# Wollongong Local Planning Panel Assessment Report | 25 September 2019

<b>WLPP No.</b>	Item 2
<b>DA No.</b>	DA-2019/527
<b>Proposal</b>	Residential - Dwelling house with attached garage, swimming pool and tree removal
<b>Property</b>	33C Woodlawn Avenue, Mangerton
<b>Applicant</b>	PDC Planners
<b>Responsible Team</b>	Development Assessment and Certification - City Centre Team (RW)

## ASSESSMENT REPORT AND RECOMMENDATION

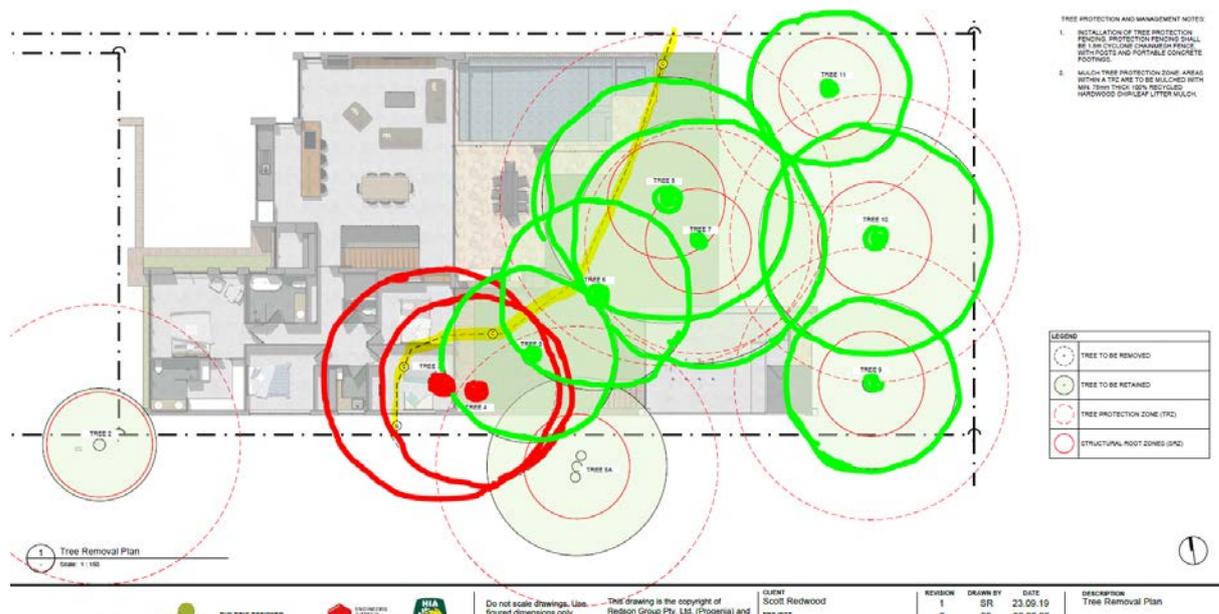
- Tree removal is proposed as part of the development. A total of two (2) trees are proposed for removal identified as 'Tree 3' and Tree 4' on the plans and in the Arborist report. The location of Tree No. 3 (*Araucaria cunninghamiana* - Hoop Pine) and Tree no. 4 (*Eucalyptus saligna x botryoides* - Wollongong Woollybutt) are indicated below and on Dwg No. L-099 within Attachment 2. These trees are proposed for removal as they are within the proposed building footprint and are identified in the arborist report as displaying 'poor health, vigour, shape and structure'.

- Earthworks – cut and fill is proposed as part of the development, including excavation up to 2.8m associated with the eastern portion of the ground floor and for the swimming pool/spa. Filling is also proposed at the rear of the dwelling to provide a level private open space area and filling under the pool room.

**Figure 2: Screen grab of DP 1208517 identifying the building exclusion zone.**

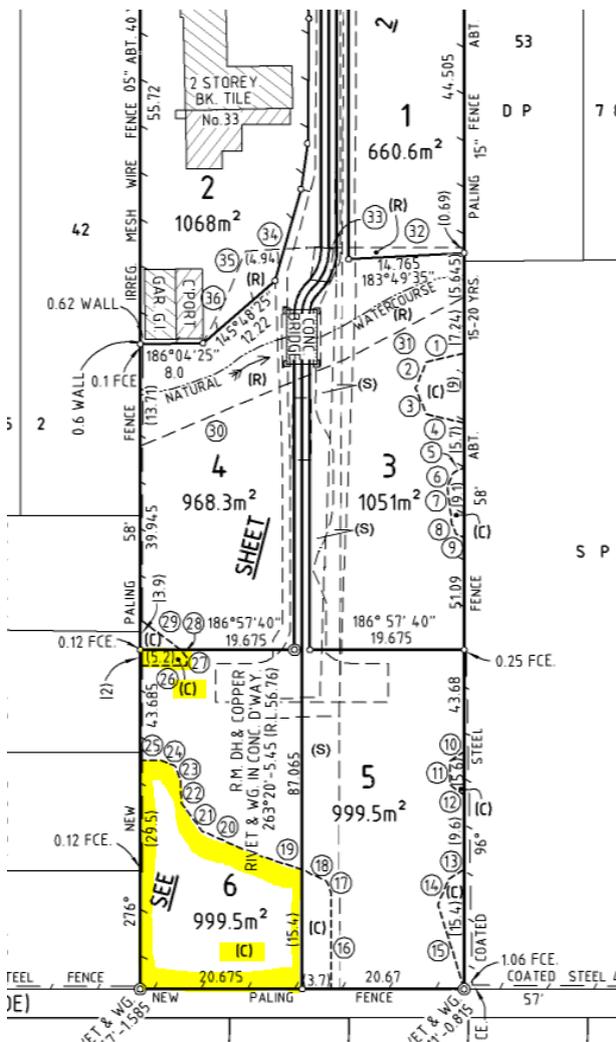
Numerous trees are present on the site within a building exclusion zone identified as Restriction 'C' on the 88B Instrument. A copy of DP 1208517 forms Attachment 4. These trees are listed below to correlate with the tree numbering on the submitted plans and Arborist report:

The Figure below identifies Lot 6 (the subject site), with the building exclusion zone identified as Restriction 'C' (highlighted):

DESCRIPTION  
 Site Waste Minimisation Plan  
 PAGE SCALE  
 1 : 250  
 PAGE SIZE  
 A3  
**G-300**

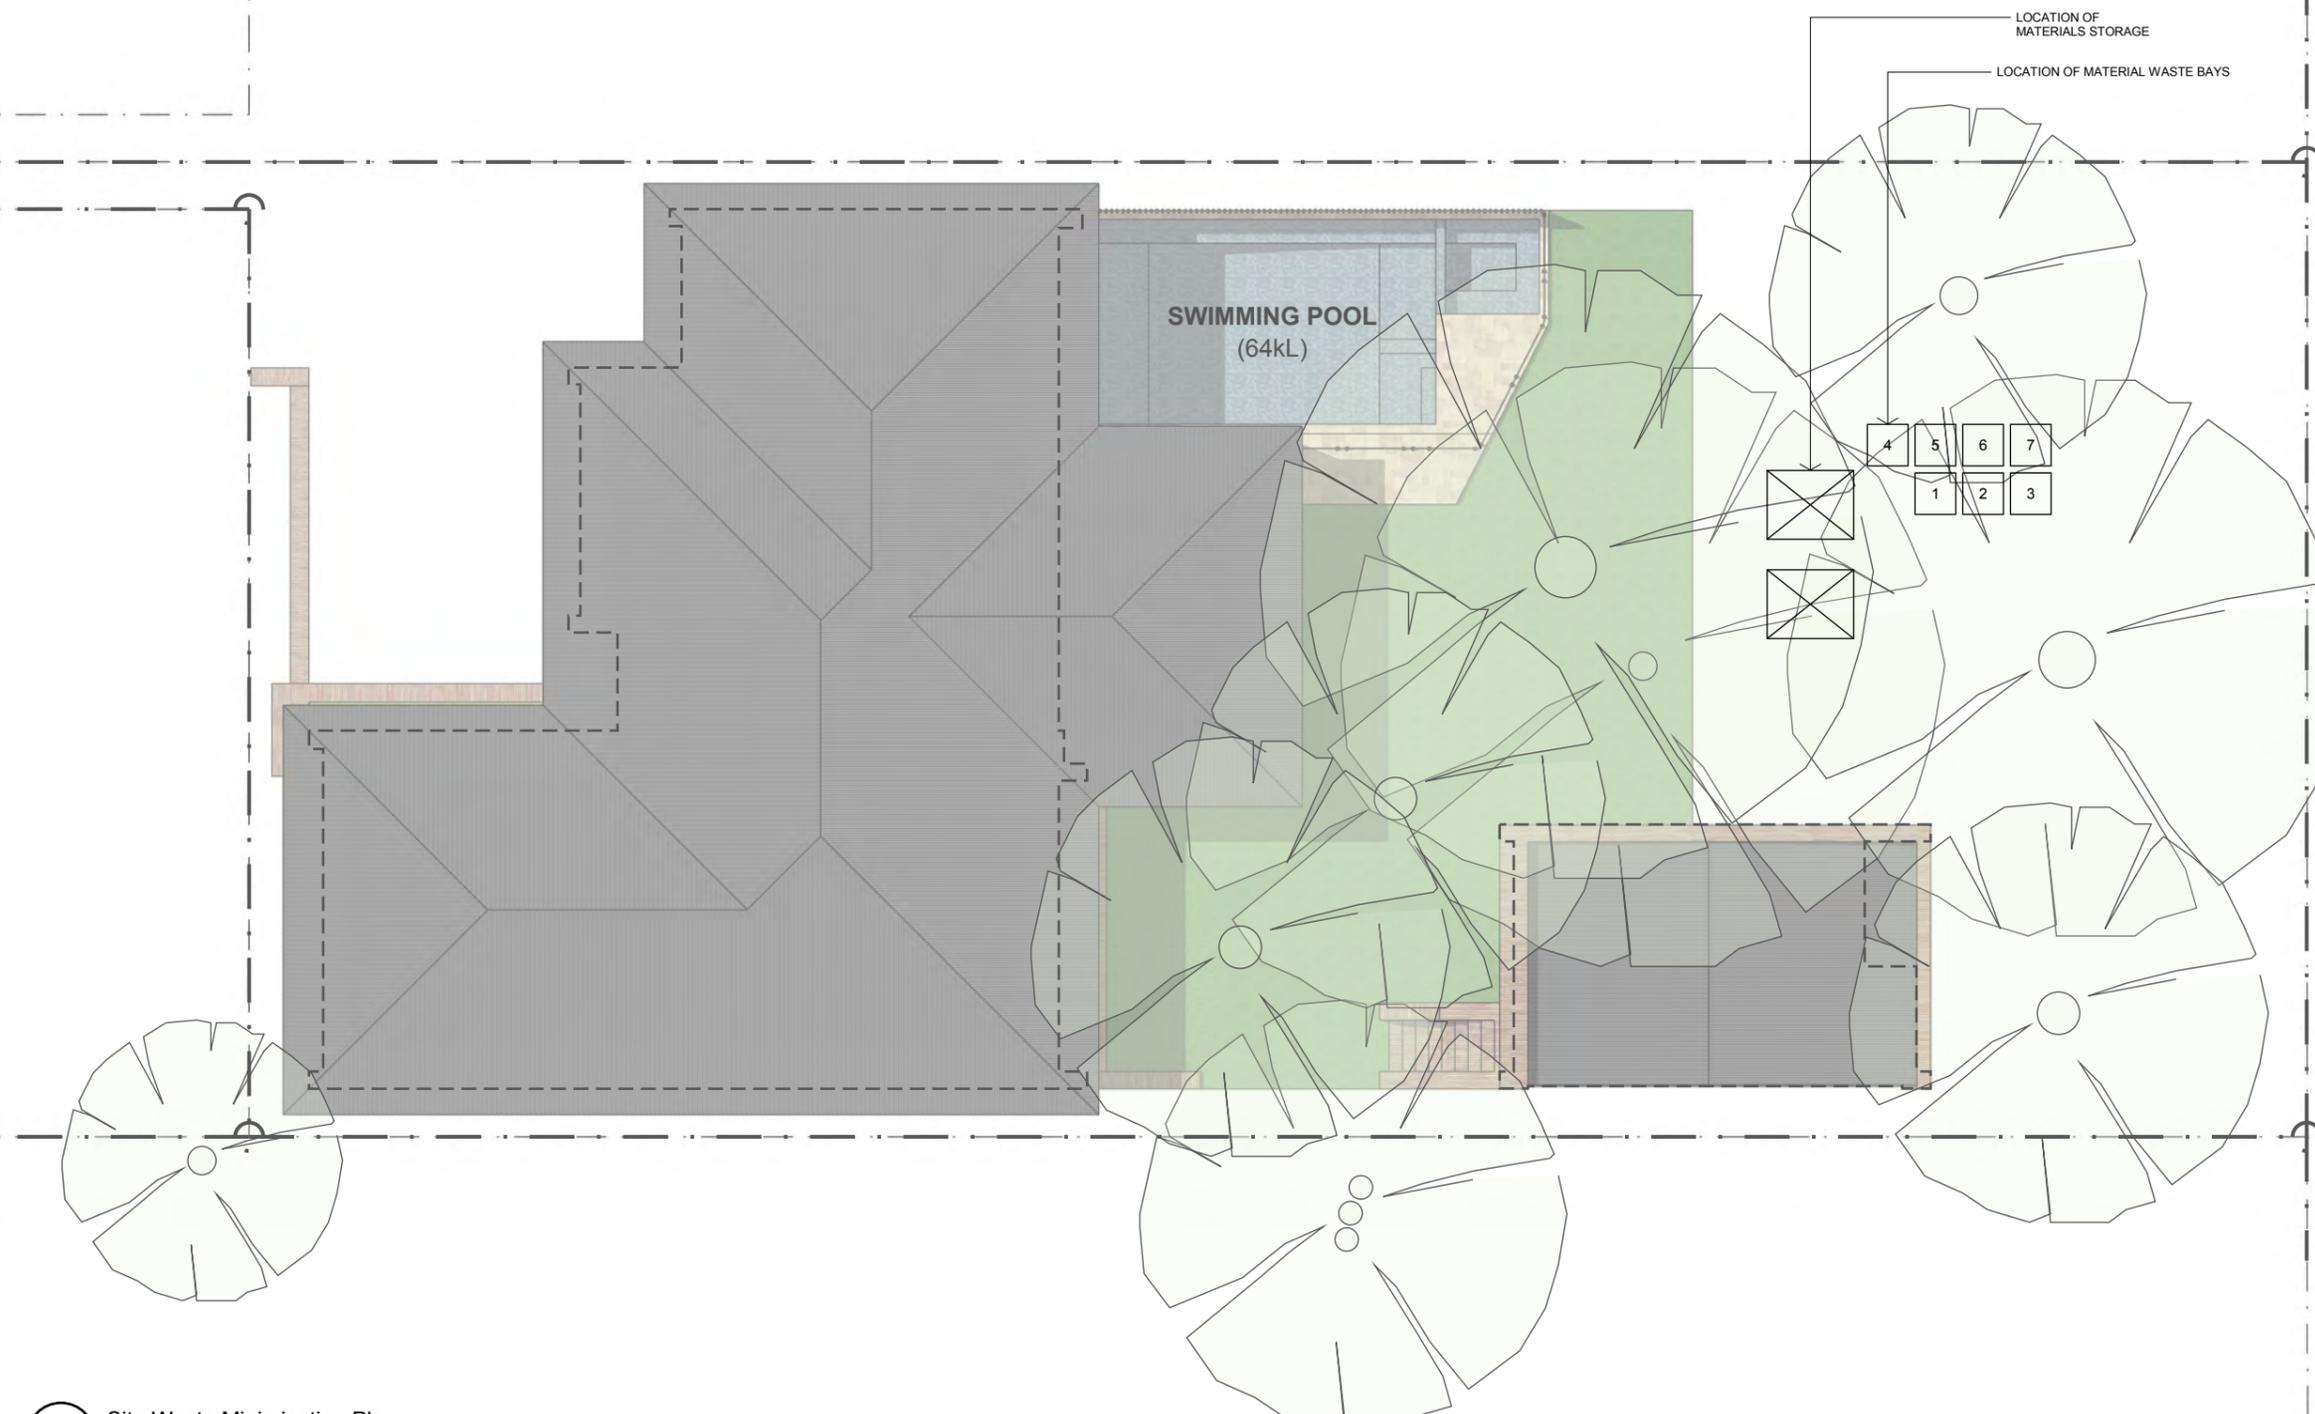
<p>20. Storage and placement of construction or excavation materials should not be permitted within close proximity of the trees to avoid damage</p>	<p>The submitted site waste minimisation plan (Dwg G-300) indicates waste bays and material storage within the building exclusion zone. Where consent is granted to a dwelling on the site, appropriate tree protection fencing would be required, and the storage of materials and construction methods would require supervision by a supervising Arborist to ensure no damage to the health of the trees results during the construction works.</p>
<p>21. Large windows and glass doors proposed close to the boundary will look into and tower over adjoining living areas, leading to visual and noise impacts. Request these be changed to highlight windows or glass brick walls to preserve privacy</p>	<p>The design of the dwelling proposes the Level 1 master bedroom and the ground level theatre room facing the western boundary. The glass sliding doors of the theatre room are located 2.56m from the western boundary. The level 1 master bedroom windows are 1.566m from the western boundary. Some screen planting is proposed adjacent to the western boundary.</p> <p>The proximity of the dwelling and the expanse of windows does not adequately respond to the site context and will lead to unreasonable privacy and amenity issues (visual bulk and acoustic privacy), as discussed in Part 2.3.1 of this report.</p>

PAGE SCALE: 1 : 100  
PAGE SIZE: A3  
**A-203**

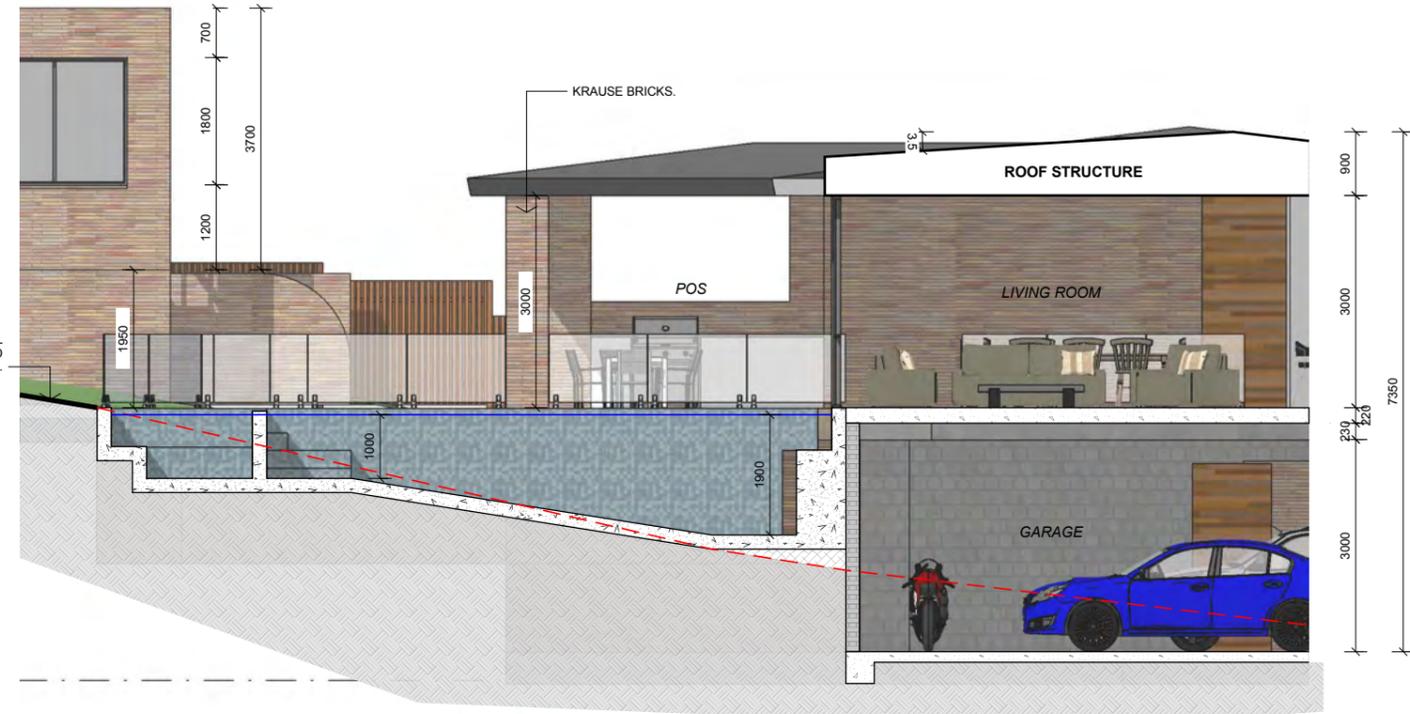
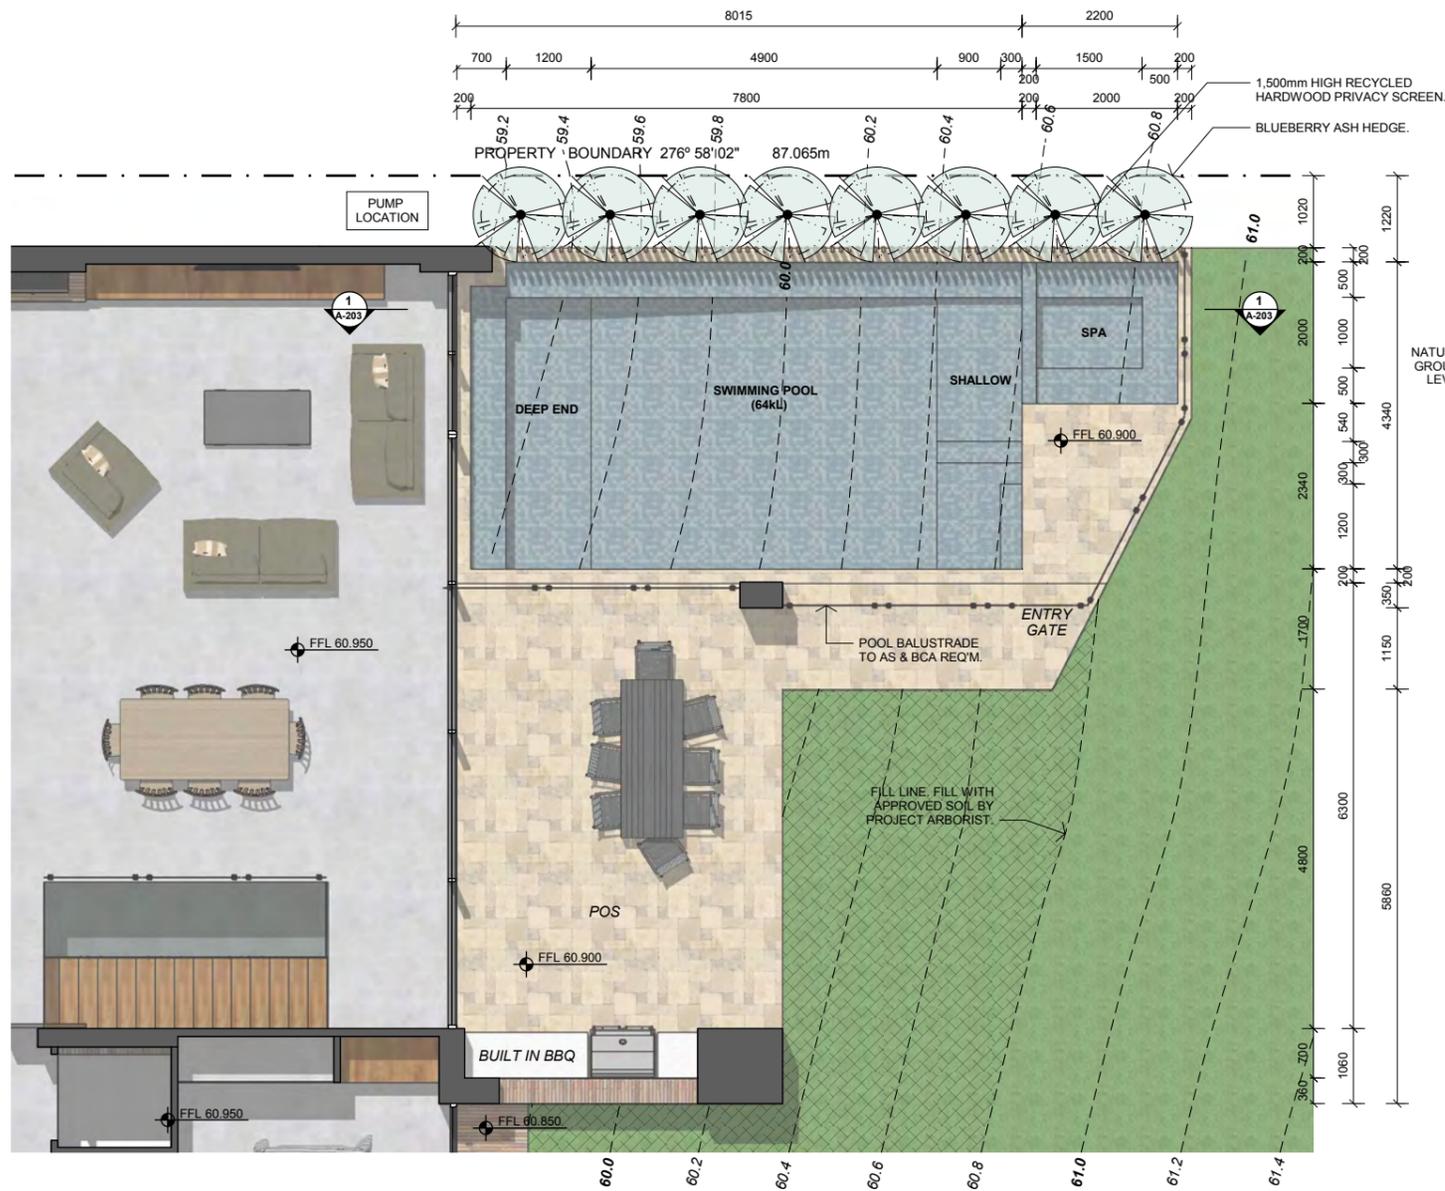
The revised BASIX Certificate requires that the swimming pool must not have a volume greater than 50kL whereas the capacity of the pool as shown on the plans exceeds this with a volume of 64kL. The volume of the spa is not identified on the plans but is required to have a maximum volume of 2.8kL. These matters would need to be addressed if the application were recommended for approval noting that the development just meets the minimum water target of 40.

The submitted Site plan and Level 1 plan (Drawing A-100 and A-201 in Attachment 2) indicate that a small corner of the proposed spa is located within the building exclusion zone identified as Restriction 'C', thereby not complying with this control.

4 West Elevation  
 Scale: 1 : 125

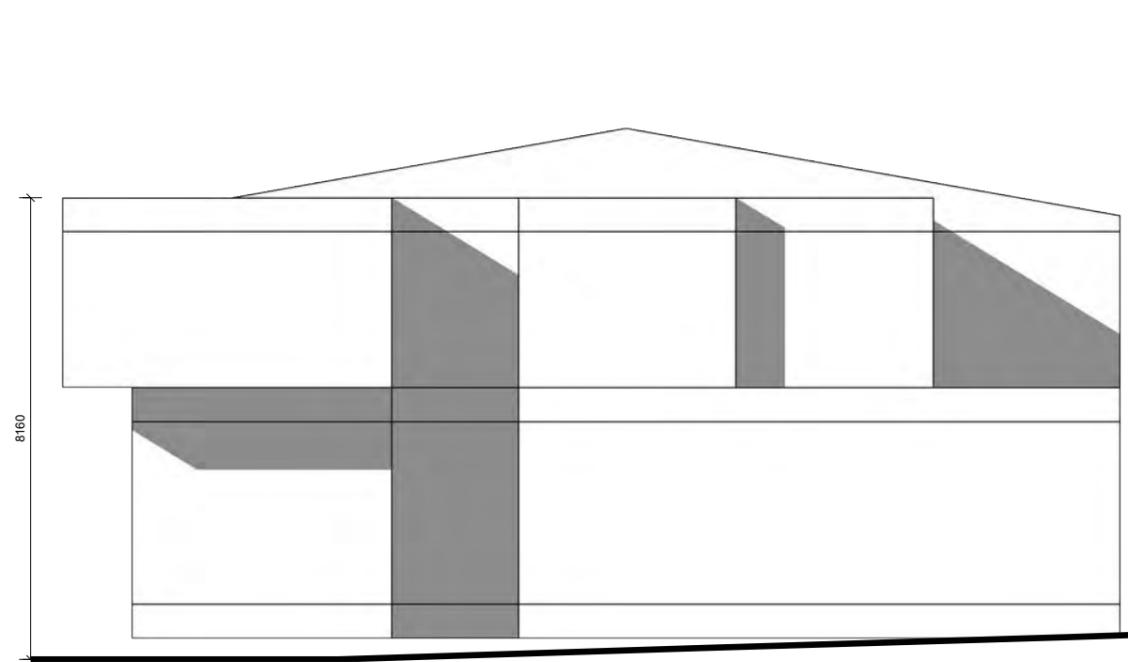
Figure 3 above shows the western elevation of the proposed dwelling. The southern side of the dwelling has a setback to the façade of between 1.5m -2.5m from the western boundary. The bedroom occupies the first floor which is excluded from this control. The ground level has expansive glass sliding doors to the theatre room. As the subject site sits higher than the adjoining western lot, the potential overlooking, and amenity impacts from this design are heightened and are unacceptable. Despite landscape screening being shown adjacent to the western boundary, acoustic impacts are still likely to occur, and the built form outcome should minimise amenity impacts. The minimal setbacks to the western boundary and extent of glazed areas do not adequately respond to this control or the objectives of Part 4.3.1.

The proposed pool room is located within the building exclusion zone and involves substantial fill resulting in its floor level being 1.7m above existing ground level (refer Figure 4 below). Given the slope of the site towards the rear boundary, the pool room will be visible above the roof line of the proposed dwelling. The pool room location and design is not sympathetic to the site constraints.
